## Separation Distance and Amenity Supplementary Planning Guidance

### Summary of Consultation Responses

Appendix 1 Summary of Consultation Responses and Officer Response

<p>↑ Illustration of the 45 Degree Check ✓</p>	
--	--	--	--	--	--

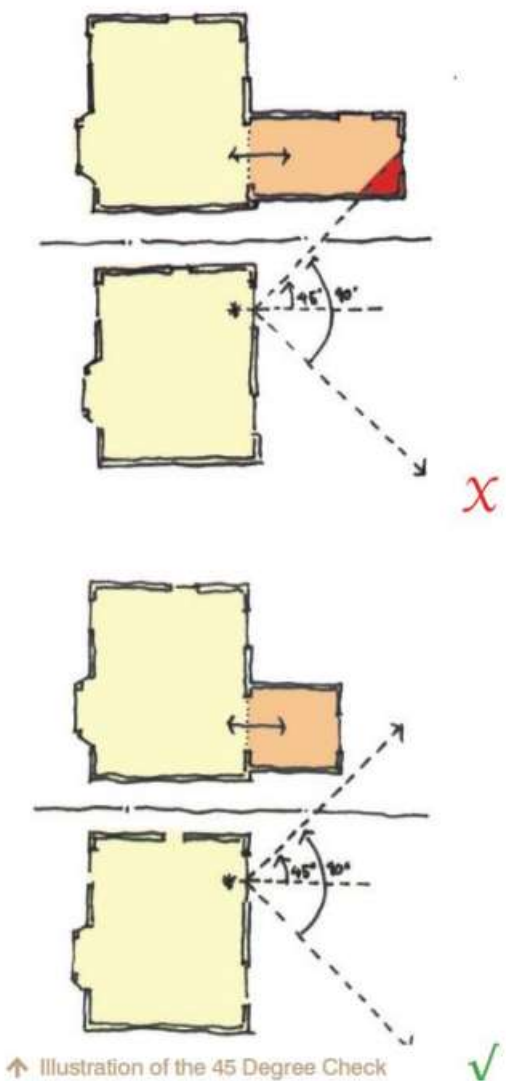
Generally – one would assume none of this to apply at a distance beyond 21m.	No change required. The standard clearly states 21metres is a minimum distance.
3	Glen Baker-Adams Development Management Tamworth Borough Council	7.6.24	Yes	<p>Just one observation from me in that this diagram seems to use odd conventions for staying what is acceptable and not. I would prefer you used a consistent approach like in previous diagrams</p> 	Noted. No change is considered necessary however changes to improve the consistency of ticks and crosses adjacent to the illustrations will be reviewed for the adoption version.
